Project	IEEE 802.16 Broadband Wireless Access Working Group < http://ieee802.org/16 >	
Title	Corrections to definitions of Uplink MIMO in OFDMA PHY	
Date Submitted	2005-01-27	
Source(s)	<p>Ran Yaniv, Tal Kaitz, Naftali Chayat, Vladimir Yanover, Danny Stopler</p> <p>Alvarion Ltd.</p> <p>Wonil Roh, JeongTae Oh, Chan-Byoung Chae, Kyunbyoung Ko, Hongsil Jeong, Sung-Ryul Yun, Seungjoo Maeng, Jaeho Jeon, Jaeyeol Kim, Soonyoung Yoon</p> <p>Samsung Electronics Co., Ltd.</p> <p>Peiyong Zhu, Wen Tong, Ming Jia, Dongsheng Yu, Hua Xu, Jianglei Ma ,Mo-Han Fong, Hang Zhang, Brian Johnson</p> <p>Nortel Networks</p>	<p>danny.stopler@alvarion.com</p> <p>ran.yaniv@alvarion.com</p> <p>tal.kaitz@alvarion.com</p> <p>wonil.roh@samsung.com</p> <p>Voice: +82-31-279-3868</p>
Re:	Call for comments, maintenance task group	
Abstract		
Purpose		
Notice	This document has been prepared to assist IEEE 802.16. It is offered as a basis for discussion and is not binding on the contributing individual(s) or organization(s). The material in this document is subject to change in form and content after further study. The contributor(s) reserve(s) the right to add, amend or withdraw material contained herein.

Correction

Figure 249—UL STC tile

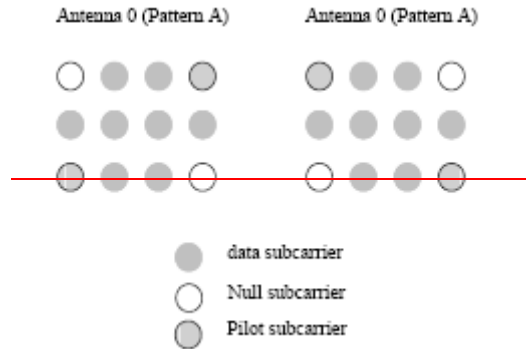
A user supporting transmission using STC configuration in the uplink, shall use a modified uplink tile. 2-transmit diversity ('STTD mode') data or 2-transmit spatial multiplexing ('SM mode') data can be mapped onto each subcarrier. The mandatory tile shall be modified to accommodate those configurations. Figure 249 depicts the UL tile for STC transmission.

Figure 249 – Mapping of data subcarriers in STTD mode.

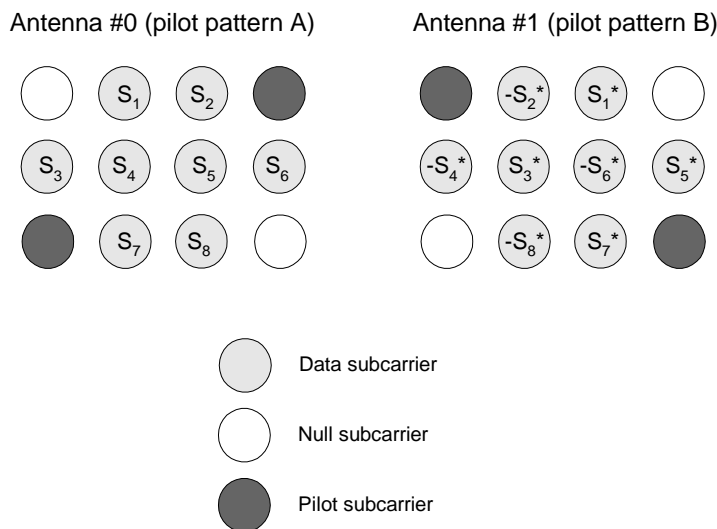
1. The data-subcarrier mapping scheme for UL STTD is not defined (8.4.8.1.5). Note that encoding subcarrier pairs across multiple tiles is not possible due to the existence of the subchannel rotation scheme.

1. Correct section 8.4.8.1.5: provide missing definition of STTD mode, define data subcarrier mapping in STTD mode.

In STTD mode, the tiles shall be allocated to subchannels and the data subcarriers enumerated as defined in 8.4.6.2. The pilots in each tile shall be split between the two antennas and the data subcarriers shall be encoded in pairs after constellation mapping, as depicted in figure 249. The data subcarriers transmitted from Antenna #0 follow the original mapping defined in 8.4.6.2.
